Title of Change:	Case outline 340CU (98AON13773G) dimension tightening per industrial standards.
Effective date:	17 Jun 2021
Contact information:	Contact your local ON Semiconductor Sales Office or Yoichi.Hoshina@onsemi.com
Type of notification:	This Product Bulletin is for notification purposes only. ON Semiconductor will proceed with implementation of this change upon publication of this Product Bulletin.
Change Category:	Assembly Change
Change Sub-Category(s):	Product specific change

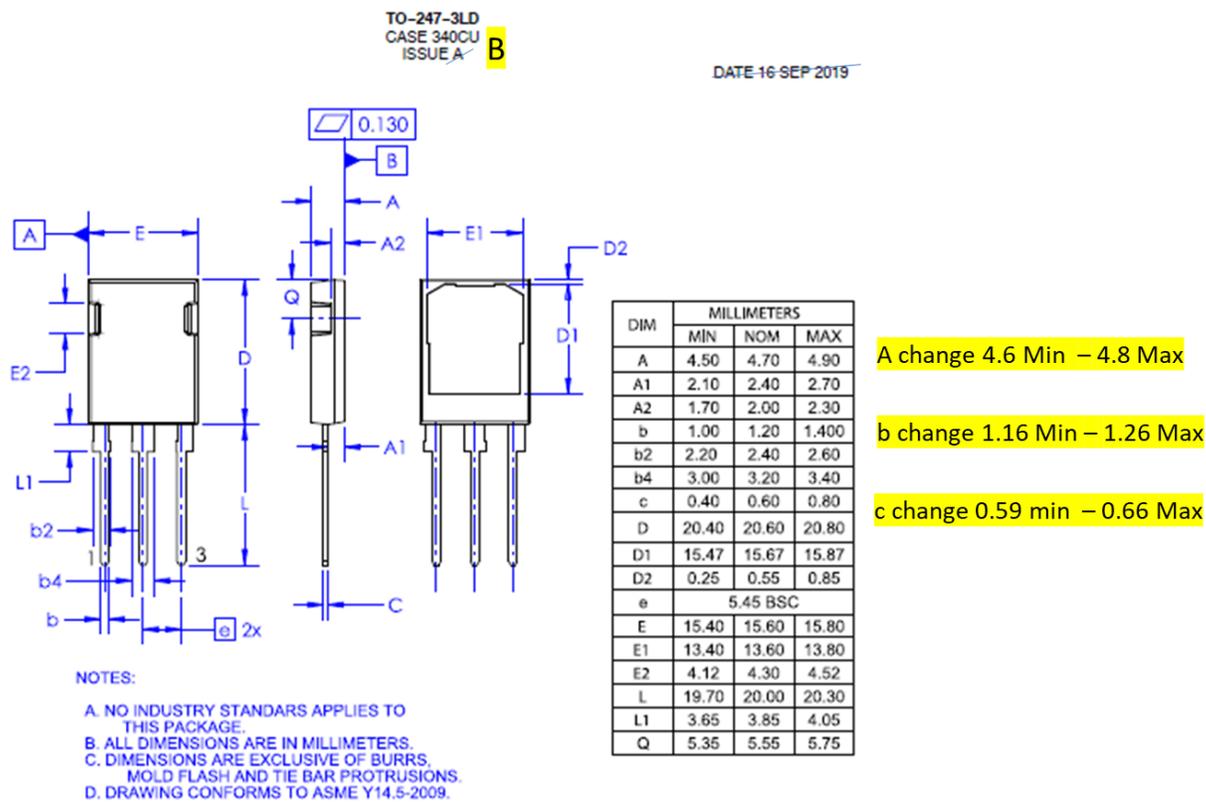
Tightening dimension measurement limit only
